# Backfeed in a 4-pair context

**Lennart Yseboodt**

Philips Lighting – Research

## 4-pair backfeed

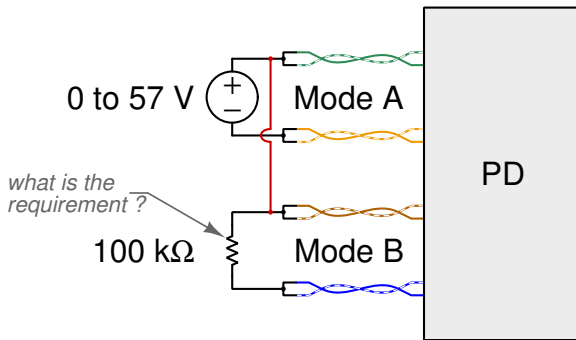
A 4-pair capable PSE typically ties the positive lines together at the PSE end. Even in “2-pair” mode, there are two pairs connected to the positive  $V_{PSE}$ . **Does the backfeed requirement still apply? Should it?**

The current text is ambiguous as to whether the condition of two positive pairs is one where backfeeding is limited to  $V_{bfd}$ . The intent of the text did not anticipate more than 2 pairs being powered (as this is old text), but it does not clearly exclude it, since connecting one pair of a Mode to a supply rail does not constitute “applying a voltage”.

We must choose to either include or exclude this configuration from the backfeed spec and change the requirement accordingly.

When any voltage in the range of 0 V to  $V_{\text{Port\_PD-2P max}}$  is applied ~~across the PI at either polarity specified on the conductors of either Mode A or Mode B according to Table 145-20~~ per any of the valid 2-pair configurations with one and only one pair connected to positive  $V_{\text{PSE}}$  listed in Table 145-20, the voltage measured ~~across the PI for~~ on the other Mode with a ~~100 k $\Omega$  load~~ resistor of 0 to 100 k $\Omega$  connected across that other Mode shall not exceed  $V_{\text{bfd}}$  as defined in Table 145-29.

Without strong indication of technical issues caused by 3-pair backfeeding, there is no reason to impose a hard to meet requirement on the PD. As such, we should adopt the “exclusion” baseline on slide 9.
